Thank you for considering our manuscript, *Optimal Control of Axial Dispersion Tubular Reactors with Recycle: Addressing State-Delay through Transport PDEs*, for publication. We are also grateful to the reviewers for their valuable comments and suggestions, which have been very helpful in improving our work.

## Reviewer 1

Figure 1: Concentration profile along the recycle stream

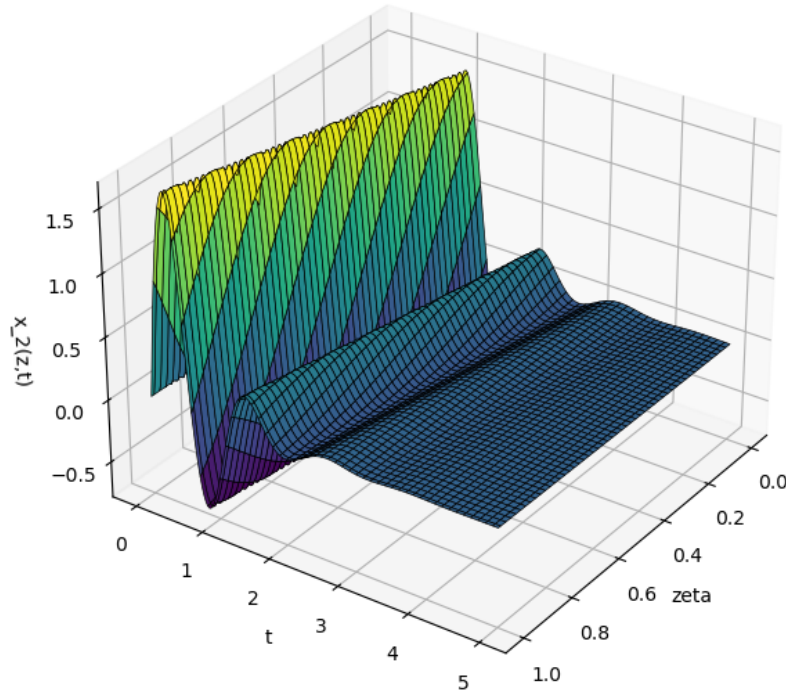
6. Page 7 - " $x_2(\zeta, t)$  is introduced as a new state variable to account for the concentration along the recycle stream"

- Why is  $x_2$  a function of  $\zeta$  ? How does  $x_2$  change across the recycle? What kind of law does it follow? To me, it seems like  $x_2$  only changes with respect to time

We have assumed that along the recycle stream, the flow of the reactant belongs to the class of pure transport PDEs. This is the case when the diffusion term and the reaction term become negligible compared to the convective term, and the state variable  $x_2$  is merely being transported along the recycle stream. Nevertheless, this still implies that  $x_2$  is a function of  $\zeta$  and  $t$ . Concentration profile along the recycle stream has not been presented in the original submission as we believe it is not the focus of this work. However, for the reviewer's reference, it is included here in the response as shown in Fig. 1.

Figure 2: Axial tubular reactor with recycle stream.

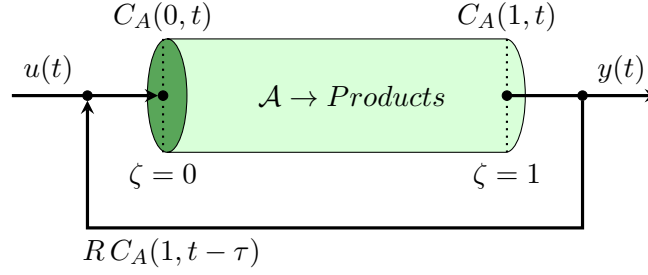
11. Page 18 - unstable dynamics of the model

- Why is the zero-input response considered unstable? Is it a qualitative assessment? What is the physical meaning of Figure 9?

We appreciate the reviewer's thoughtful questions regarding the zero-input response and its interpretation. As mentioned previously, the original submission focused on the broader goals of the study, offering a concise explanation of the proposed model. However, based on the reviewers' feedback, we recognized the need to address potential misunderstandings caused by this brevity. To address this query comprehensively, we aim to clarify the modeling approach by outlining the modeling steps and the reasoning behind the chosen framework here in the reply, as they are critical for understanding the observed instability and its implications. In addition, we have also updated the manuscript to provide a more detailed and general explanation of the model. These revisions ensure that the manuscript presents a clearer and more comprehensive framework while preserving the original model's intent and structure.

For the axial dispersion tubular reactor presented in Fig. 2, the molar balance equation may be written for the reactant concentration,  $C_A$ , as follows:

As a result, the zero-input response is considered unstable due to the positive reaction term in the model. Figure 9 illustrates the unstable dynamics of the linearized model in the vicinity of the steady-state in the absence of control input; with the qualitative assessment that a deviation from the steady state may draw the system to a different steady state, resulting in completely different model dynamics than the one used to design and control the system for optimal operation. The manuscript has been updated to include more detailed explanation in this regard.
